CITY OF ALBUQUERQUE

Re: Renovation to an existing building Shell
10921 Central Ave. NE
Traffic Circulation Layout
Architect's Stamp 11-09-22 (L21-D030)

Based upon the information provided in your submittal received 11-14-22, the above referenced plan cannot be approved for Building Permit until the following comments are addressed:

TCL

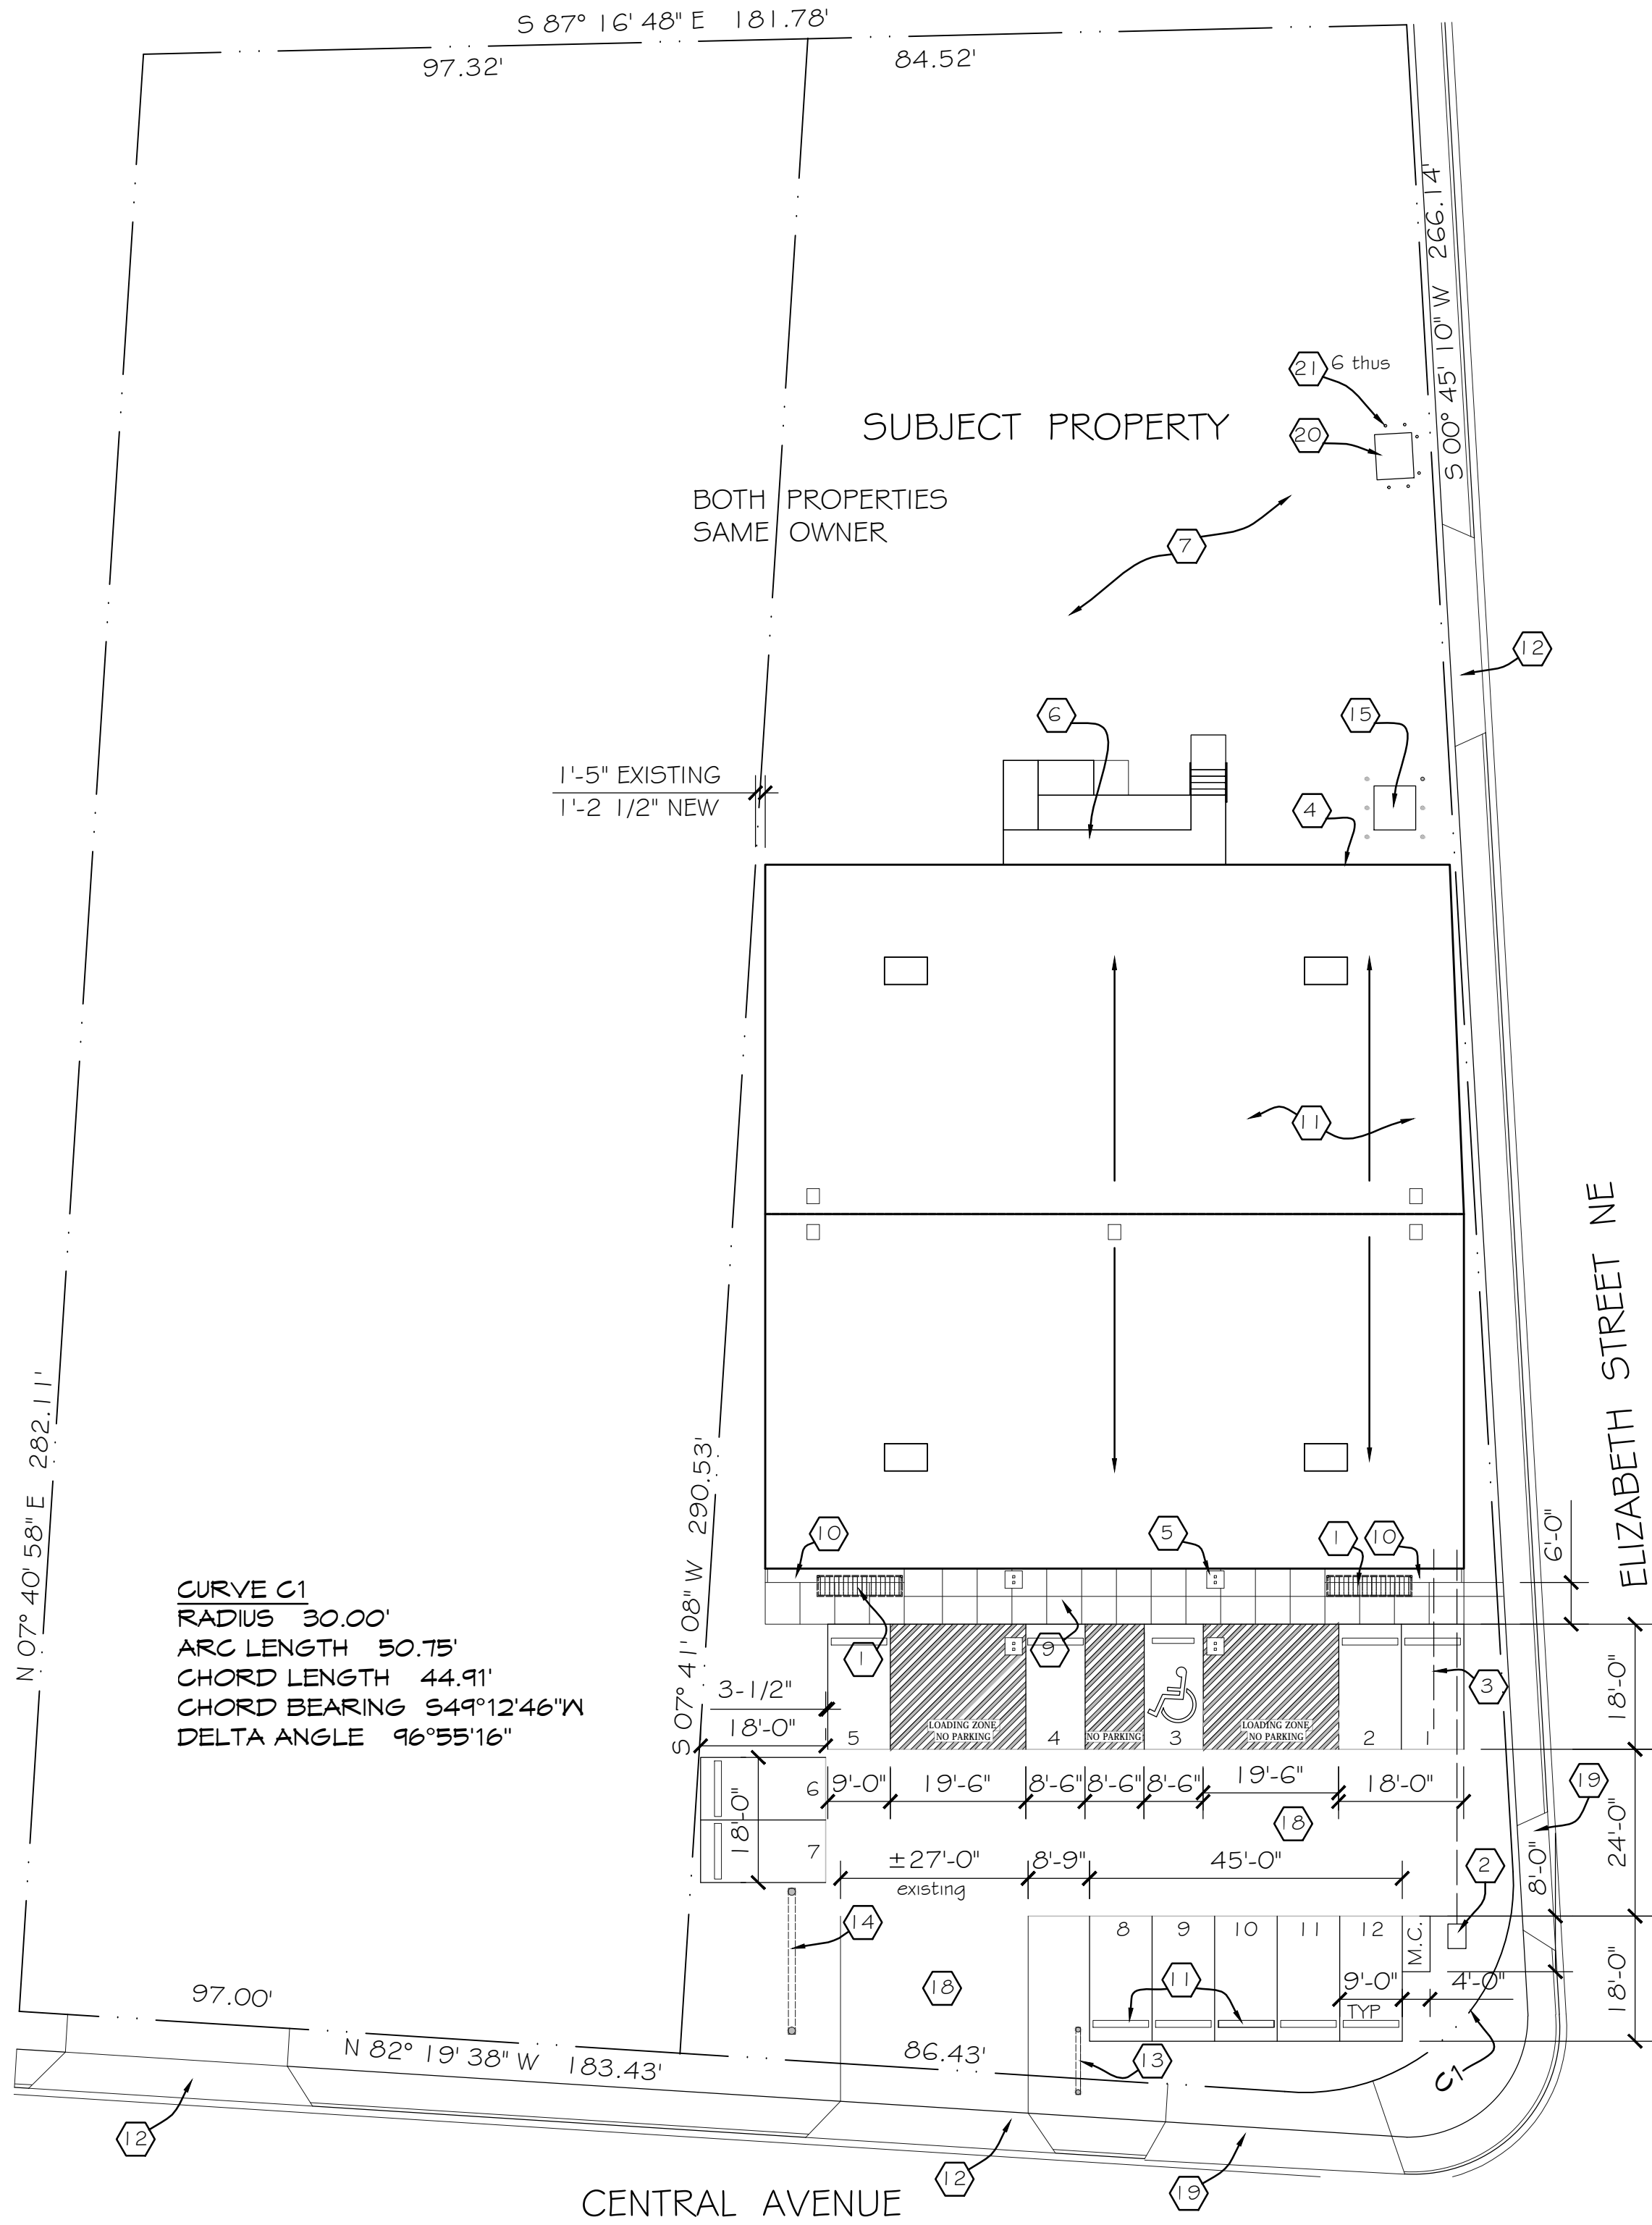
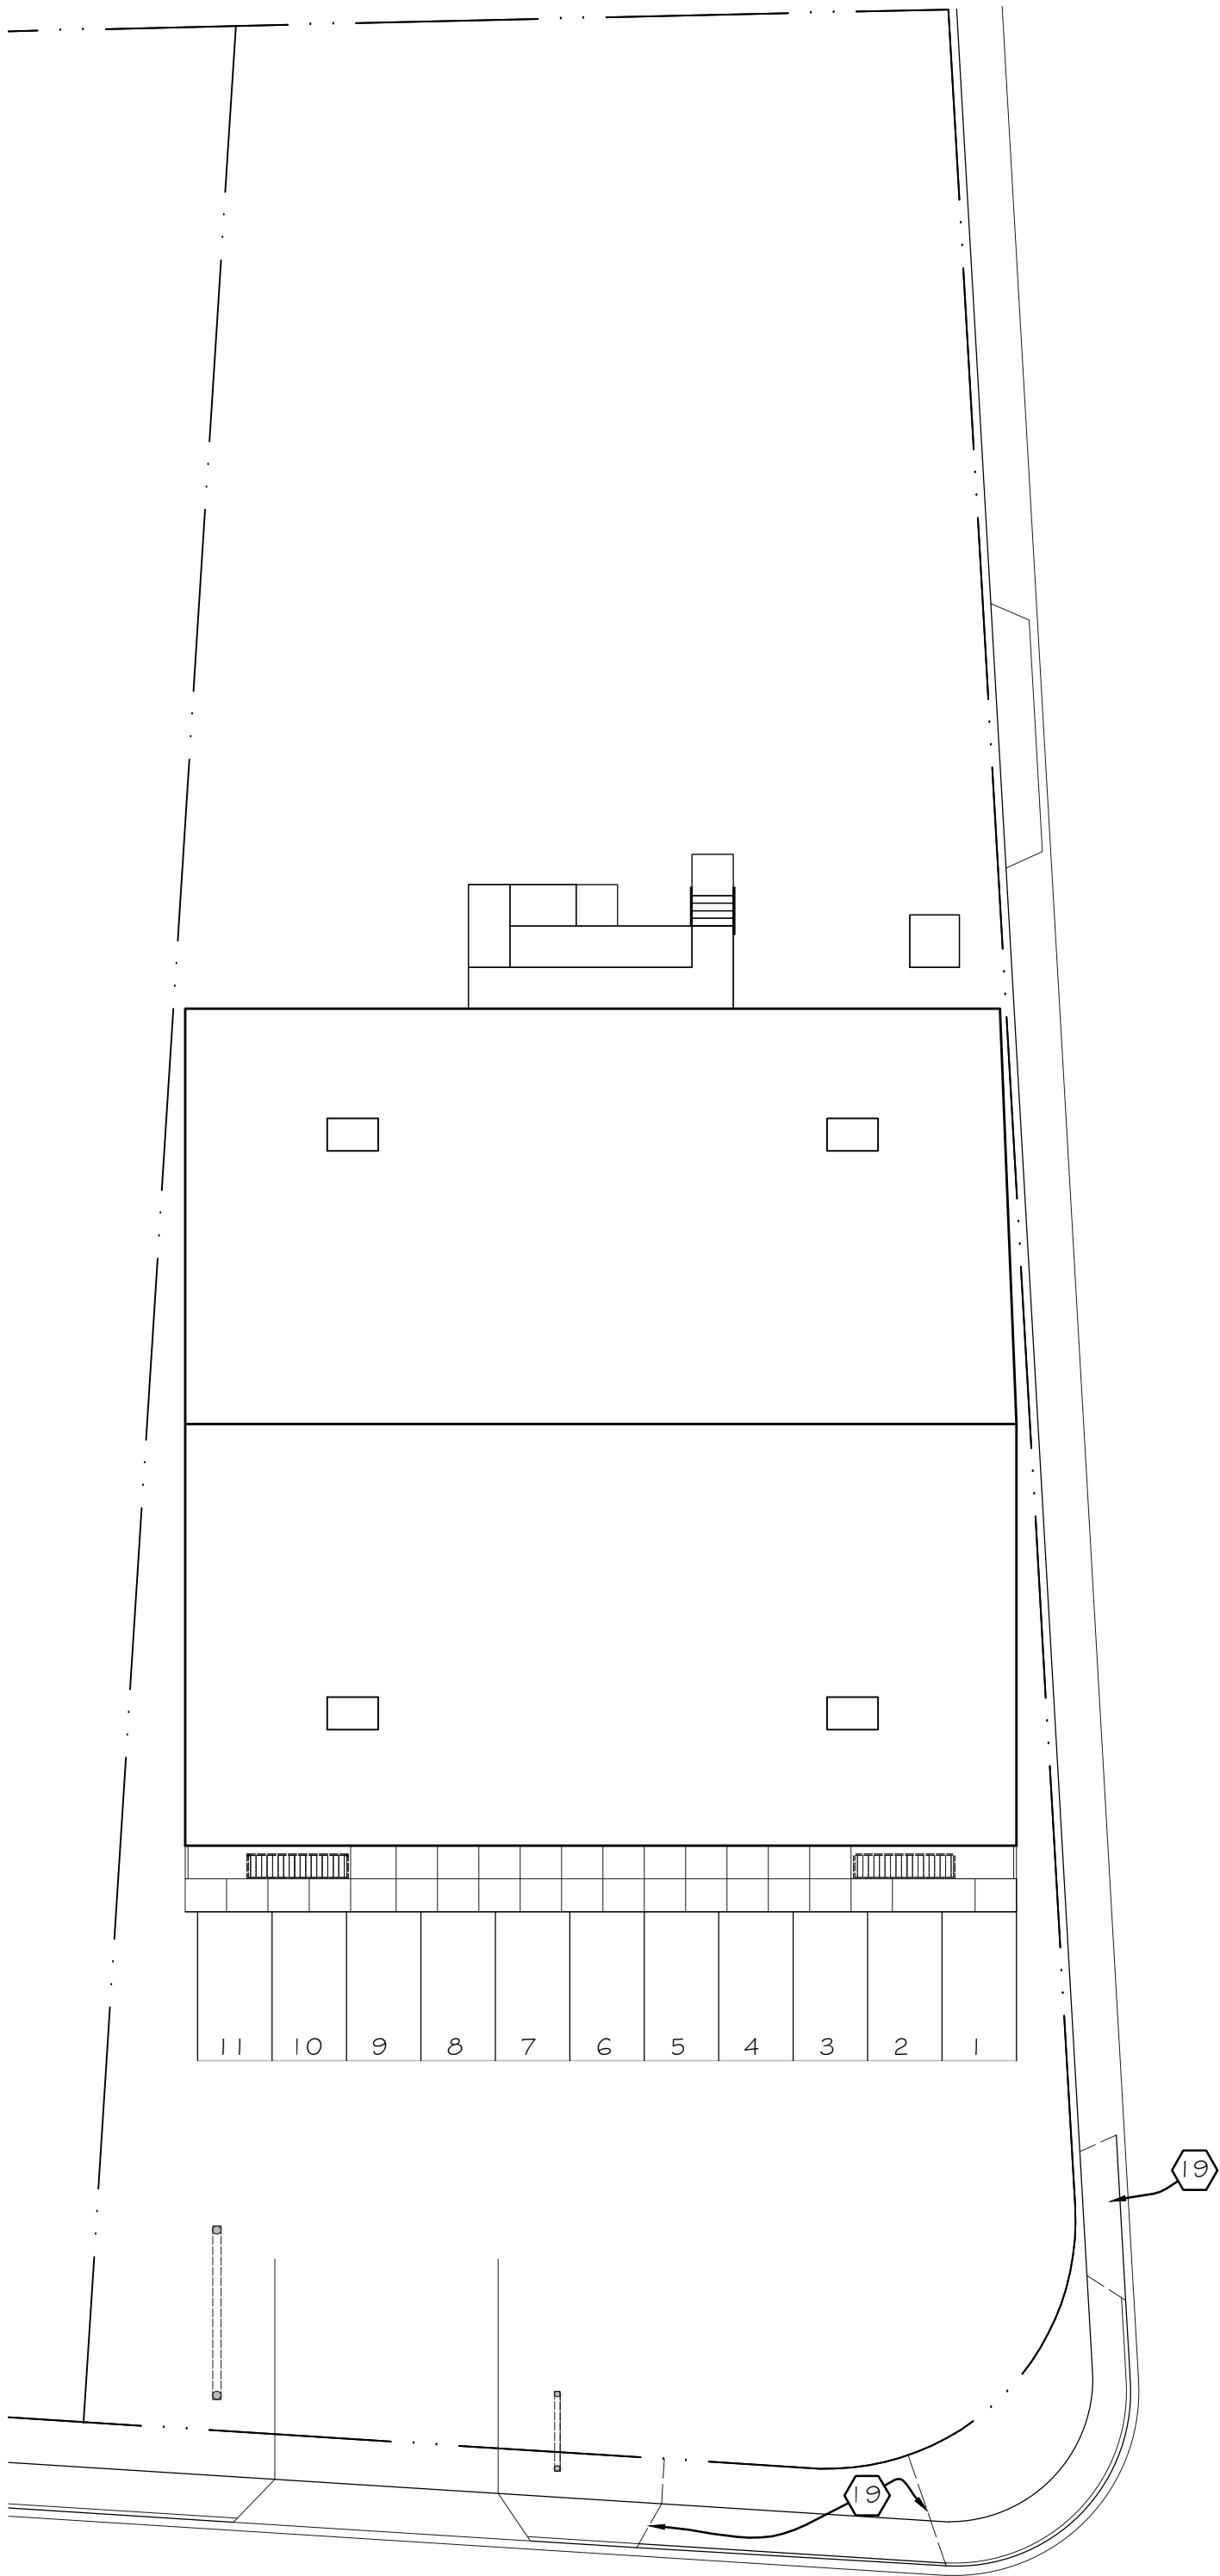
1. List the number of parking spaces required by the IDO as well as the proposed number of parking spaces including bicycle and motorcycle parking.
2. Identify all existing access easements and rights of way width dimensions.

3. Identify the right of way width, medians, curb cuts, and street widths on Central Ave. and Elizabeth St.
4. Provide the existing site accesses width.

5. Site accesses should be ADA compliant.
6. Please provide shared access agreement's with the adjacent property.
7. The ADA accessible parking sign must have the required language per 66-7-352.4C NMSA 1978 **"Violators Are Subject to a Fine and/or Towing."** Please call out detail and location of signs.

8. ADA curb ramps must be updated to current standards and have truncated domes installed.
9. Motorcycle parking spaces shall be designated by its own conspicuously posted upright sign, either free-standing or wall mounted per the zoning code.

10. The pavement marking "MC" should be shown in the opposite direction for motorcycles entering the parking space.
11. All bicycle racks shall be designed according to the following guidelines:

- e. The user is not required to lift the bicycle onto the bicycle rack.
- f. Each bicycle parking space is accessible without moving another bicycle.
- 12. Bicycle racks shall be sturdy and anchored to a concrete pad.
- 13. A 1-foot clear zone around the bicycle parking stall shall be provided.
- 14. Bicycle parking spaces shall be at least 6 feet long and 2 feet wide.
- 15. Show all drive aisle widths and radii. Some dimensions are not shown.
- 16. The minimum drive aisle dimensions are shown below

- 17. Define ADA pathways from the public sidewalk and from the ADA aisle to the building entrance, by labeling of ramps, flush pavement, dimensioning of pathways, doorways, etc.

- 18. Show the clear sight triangle and add the following note to the plan: "Landscaping and signage will not interfere with clear sight requirements. Therefore, signs, walls, trees, and shrubbery between 3 and 8 feet tall (as measured from the gutter pan) will not be acceptable in the clear sight triangle.

- 19. Key note 19: please reference COA std dwg 2430.

- 20. Please specify the City Standard Drawing Number when applicable.

- 21. Add a note stating "All broken or cracked sidewalk must be replaced with sidewalk and curb & gutter." A build note must be provided referring to the appropriate City Standard drawing.
- 22. Please provide a letter of response for all comments given.
- 23. Traffic Studies: See the Traffic Impact Study (TIS) thresholds. In general, a minimum combination of 100 vehicles entering and exiting in the peak hour warrants a Traffic Impact Study. Visit with Traffic Engineer for determination, and fill out a TIS Form that states whether one is warranted. In some cases, a trip generation may be requested for determination (**Contact Matt Grush: mgrush@cabq.gov**).
